MFN 06-466, Supplement 4

Subject: **Response to Portion of NRC Request for Additional
Information Letter No. 116 Related to ESBWR Design
Certification Application, RAI Number 6.2-102 S02**

RAI Number 6.2-102 S02

Figure 1 – PCCS Fault Tree Modification (WP-TOPDHR was an EQU Gate)

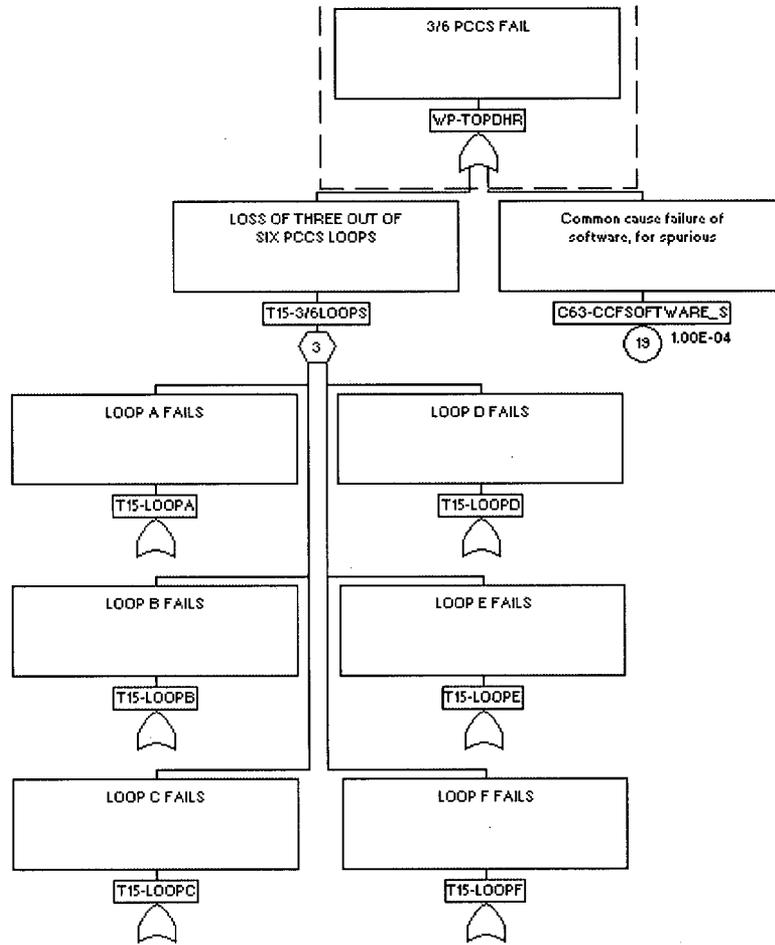
Please provide the risk analysis performed to support GEH's conclusion that from a risk perspective it is safer not to have CIV's in the PCCS. Include a comparison of the probability of CIV failure to the probability of a leak in the PCCS.

As only 4/6 PCCS loops are required for successful containment heat removal, the only significant failure mode emerged to be inadvertent actuation of the isolation valves by the Q-DCIS. That is, individual spurious valve closure did not contribute to increased risk. Effectively, the model change required to simulate the containment isolation valves involved changing top gate "WP-TOPDHR" for PCCS from an "EQU" gate to an "OR" gate with two inputs:

- T15-3/6 LOOPS: "Loss of three out of six PCCS loops" (from the current PRA model)
- C63-CCFSOFTWARE_S: "Common cause failure of software, for spurious"

The actual fault tree modification is shown in Figure 1.

- The CDF increased from $1.066E-8$ /yr to $8.076E-7$ /yr
- Non-TSL (nTSL) release frequency increased from $8.64E-10$ /yr to $8.00E-7$ /yr (note that the $9.62E-10$ /yr quoted above is a result of $1E-15$ /yr truncation)
- Conditional Containment Failure Probability (CCFP) increased from 0.079 to 0.991

The CDF rises noticeably with the addition of PCCS isolation valves, but the significant result is the increase in CCFP to almost 1.0. Introducing the spurious software failure as a failure mode to PCCS significantly reduces its reliability and places more importance on other methods of containment heat removal. A summary of the probability that the containment isolation valves fails PCCS versus the probability of a PCCS leak is provided in Table 1.
